IGNITION SWITCH / 1974 FX, FXE, XL, XLCH

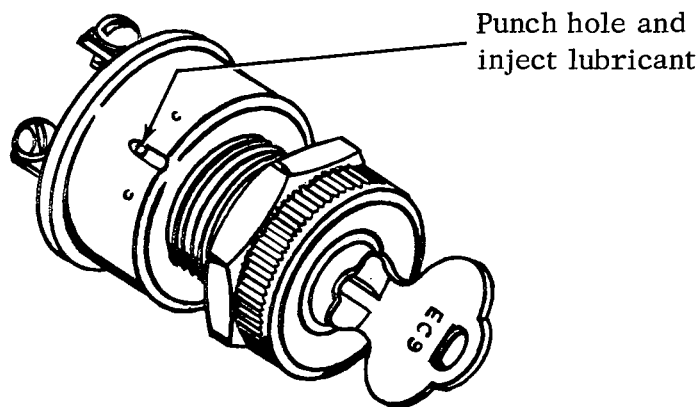
Due to a production oversight on 1974 models, lubricant was omitted on the ignition key switch indexing plate, which could cause the switch to bind.

The lubricant can be injected into the switch after removing the switch from the vehicle and punching a small hole in the notched area as shown below.

If this lubrication injection doesn't remedy the binding, inject lubricant into the 1/8" tumbler lubrication hole located in the mounting nut thread area.

To remedy or prevent a binding problem, lubrication with a silicone lubricant is recommended.

Continued binding indicates switch is defective and should be replaced using Part No. 71500-59A.
